STAFF REPORT

HEARING 9/14/2021
DATE:
TO: Mayor & City Council
FROM: Joe Dodson, Associate Planner
208-884-5533
SUBJECT: H-2021-0036
Briar Ridge Subdivision

LOCATION: The site is located on the west side of Meridian Road between W. Lake Hazel Road and W. Amity Road, directly south of the mid-mile point, in the NE ¼ of the SE ¼ of Section 36, Township 3N., Range 1W.

B. Preliminary Plat (dated: ~~4/7/2021~~ 9/3/2021)

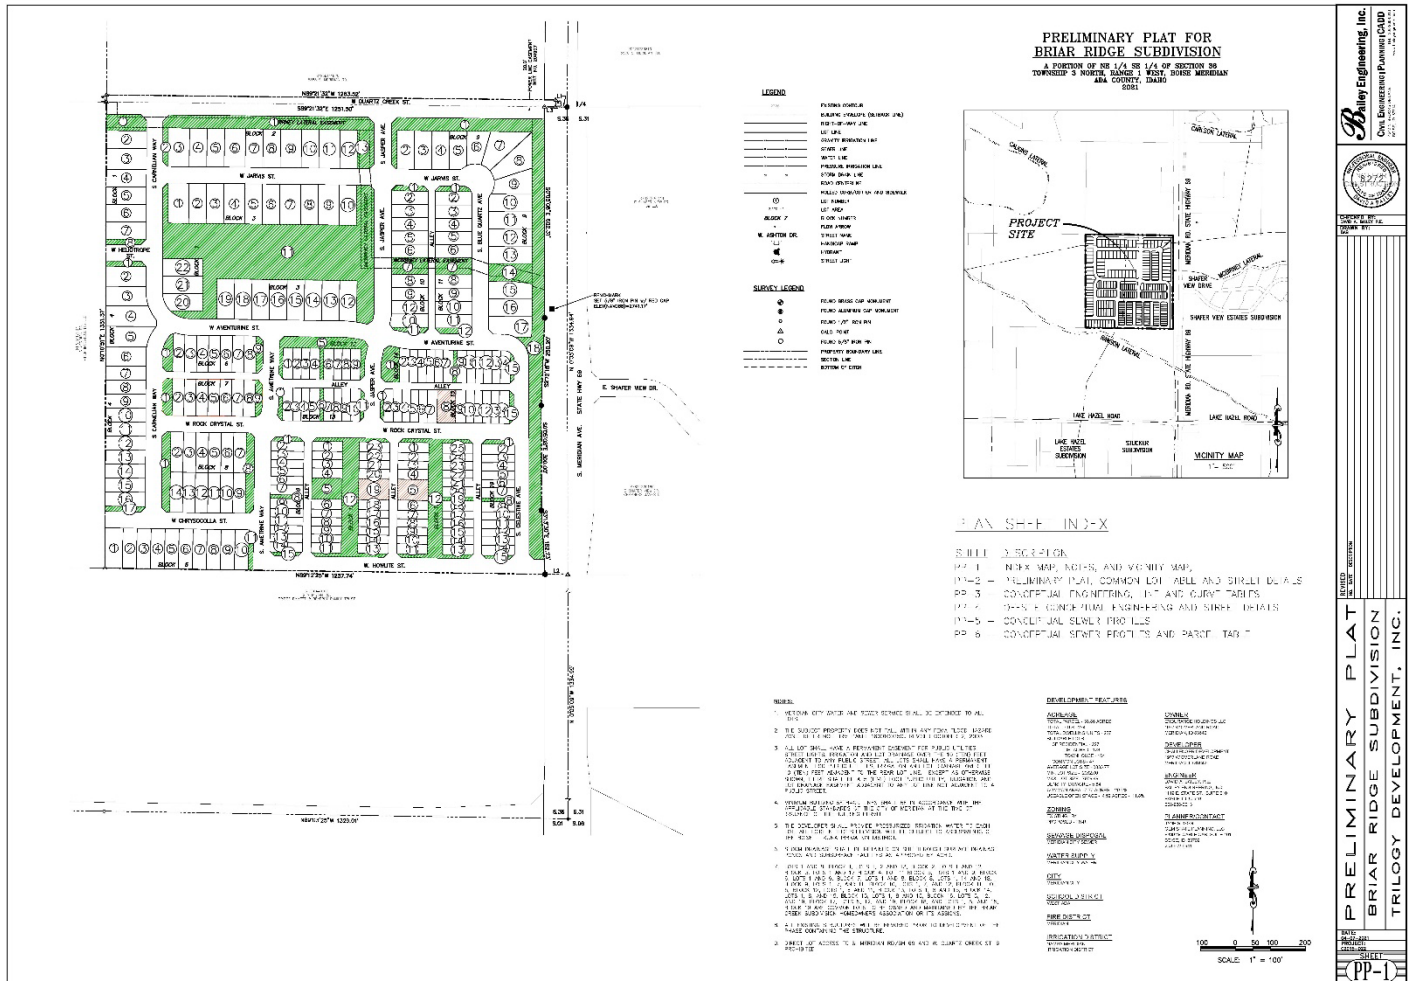
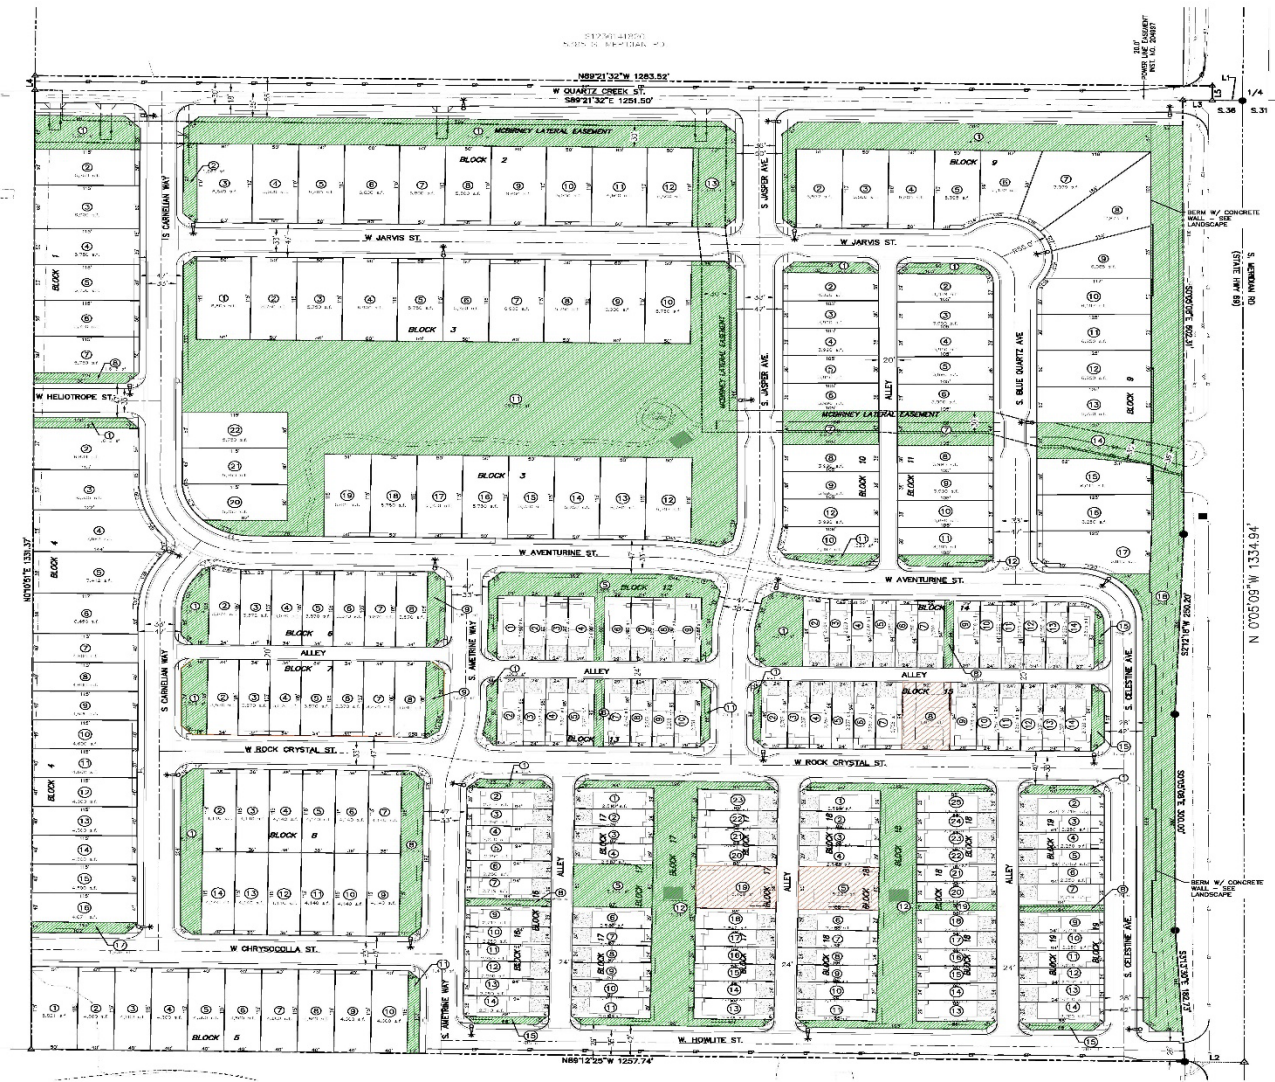
Note: The alleys shown on the plat for the attached units in the southeast quadrant of the project do not meet ACHD policies for an alley because the units front on green space instead of a public road. Therefore, this alley must instead be constructed as a “minor urban local street” which is a minimum of 24 feet wide with curb and gutter and no parking is allowed on either side. Staff is recommending a condition of approval in line with ACHD’s condition to ensure this street segment is revised and has coordinated with ACHD to not require sidewalks on these internal “alleys” because the project is proposed with detached sidewalk and parkways throughout the entire development. The Applicant should revise the width of these roads to meet ACHD policy—this may lead to a reduction in green space between these units.

- a. ~~Revise the plat to reorient remove building lots (Lots 13-1716 & 17, Block 3 and Lots 18-25, Block 3) on the west and south side of the large open space lot (Lot 1, Block 3) to open up this central open space lot for visibility and access mirror the layout on the north side of this lot to only have lots on the south side of the open space lot fronting on W. Aventurine Street, per the analysis in Section V.L.~~

- b. ~~Revise the proposed alleys between the townhome lots in Block 17 & Block 18 to be minor urban local streets constructed at a minimum of 24 feet wide with curb and gutter, no sidewalks, and no parking on either side, per ACHD requirements.~~

- c. ~~Add striping or other traffic calming measures (i.e. bulb outs) where the proposed multi-use pathway crosses local streets within the development; coordinate with Meridian Fire and ACHD as necessary.~~

- d. ~~Add a plat note stating that direct lot access to S. Meridian Road/SH 69 and W. Quartz Creek Street is prohibited.~~
3. The landscape plan included in Section VII.C, dated March 10, 2021, shall be revised as follows prior to ~~the City Council hearing~~ Final Plat submittal:

2. The preliminary plat included in Section VII.B, dated ~~April 7, 2021~~ September 3, 2021, ~~shall be revised as follows prior to the City Council hearing:~~ is approved as submitted.

C. Landscape Plans (date: 3/10/2021)

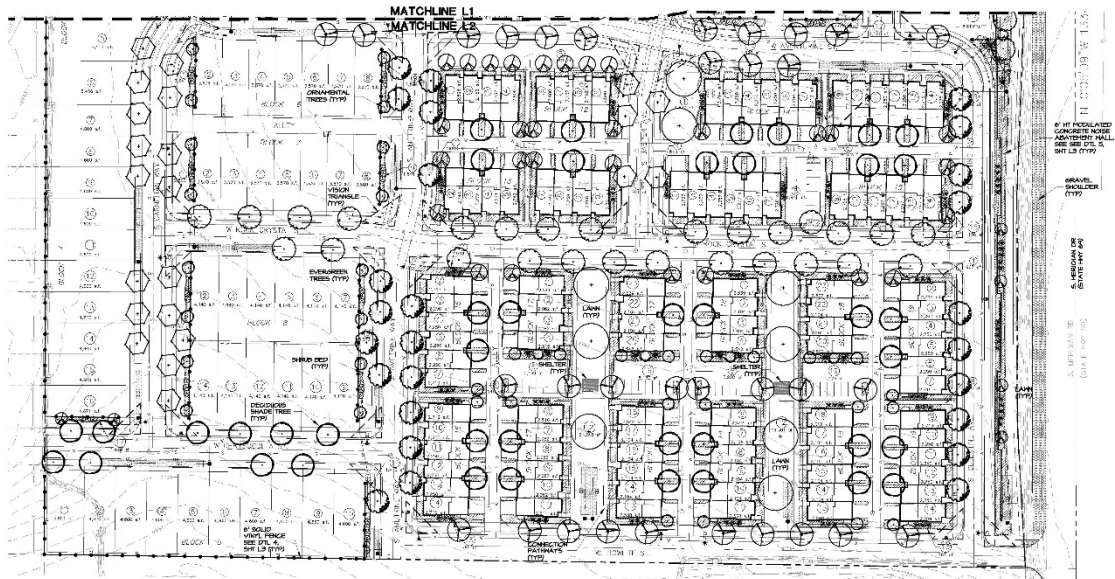
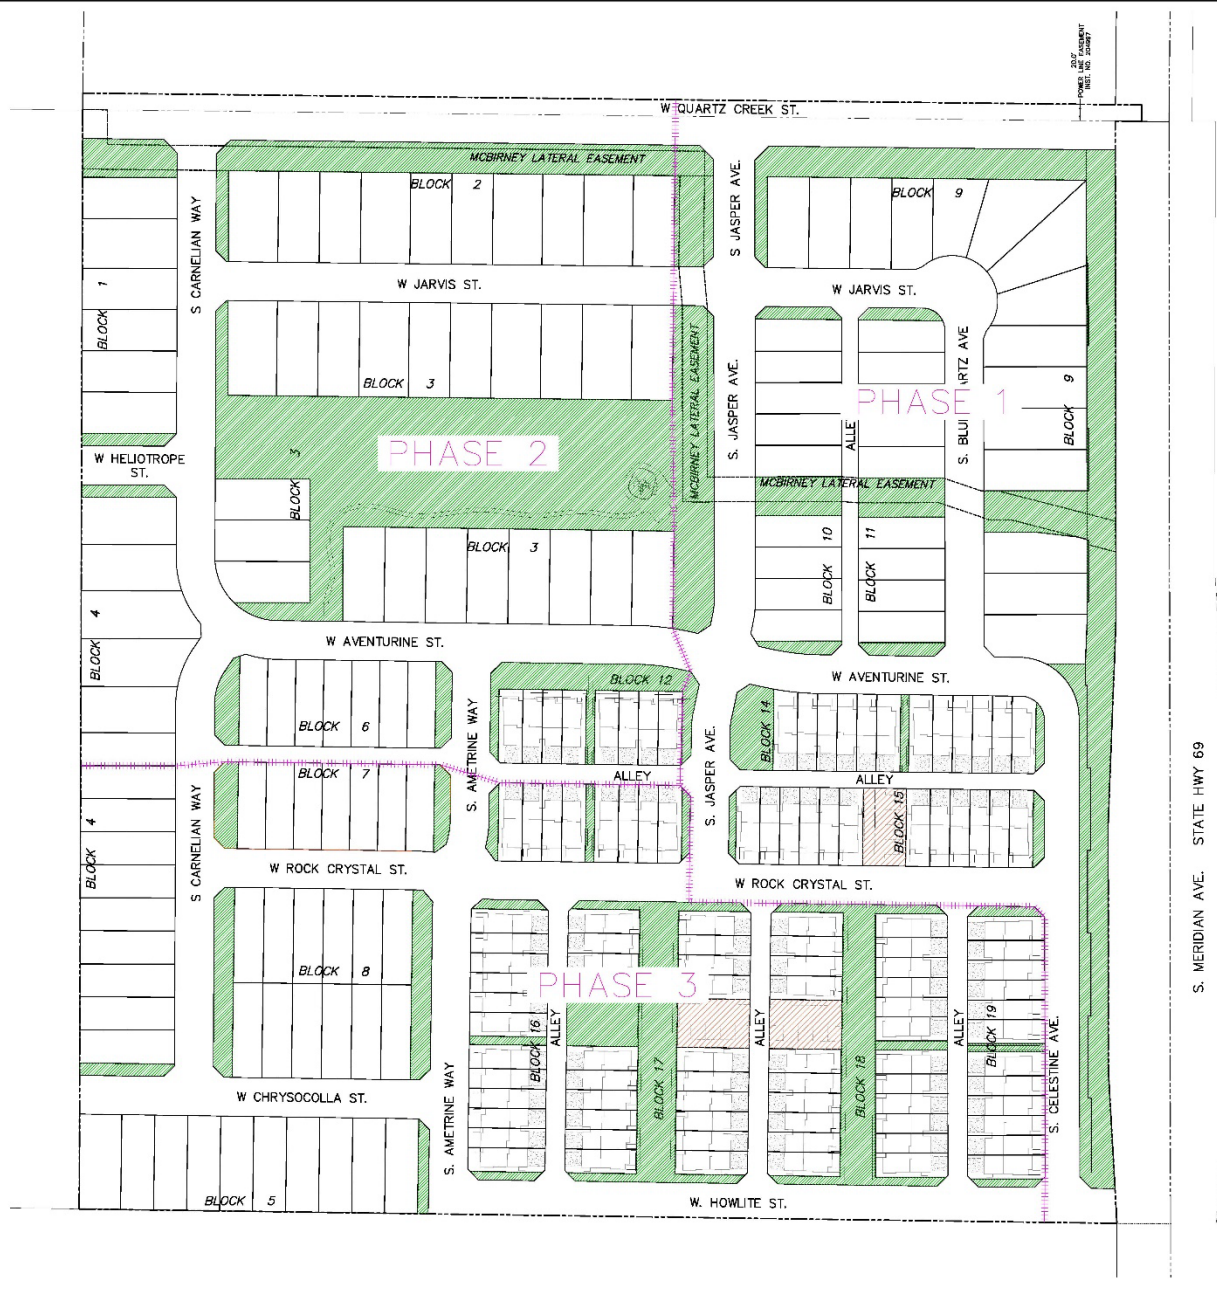
All fencing is required to comply with the standards listed in UDC 11-3A-7. Fencing is proposed as shown on the landscape plan and appears to meet UDC standards as proposed except for the 6-foot closed vision fencing proposed adjacent to the large open space lot (Lot 1, Block 3) in the north half of the site and shown on the rear lot line of the homes surrounding this open space lot.

Per UDC 11-3A-7A.7b, when an open space lot is greater than 250 feet in length, an open vision or semiprivate fence shall be used. The closed vision fencing shown on the landscape plans does

not comply with this code section. The Applicant should revise the landscape plan at the time of the applicable final plat application. Staff's recommendation to make this open space lot more linear in nature does not remove the need for this fencing revision because the lot is deeper than 250 feet.

- a. Revise the landscape plan to match the revised plat revisions noted in VIII.A2 above.
 - b. Show striping or other traffic calming measures (i.e. bulb-outs) where the proposed multi-use pathway crosses local streets within the development; coordinate with Meridian Fire and ACHD as necessary.

- c. Prior to Final Plat submittal, add two (2) new lines of calculations in the landscape calculations table to show the linear feet of parkways and linear feet of pathways and include the required number of trees and proposed number of trees in accord with UDC 11-3B-7C.

- d. Any landscaping within the ITD right-of-way shall be landscaped in accord with UDC 11-3B-7C.5.
4. With the Final Plat submittal submit a revised open space exhibit showing the changes to the preliminary plat layout and change in open space area.
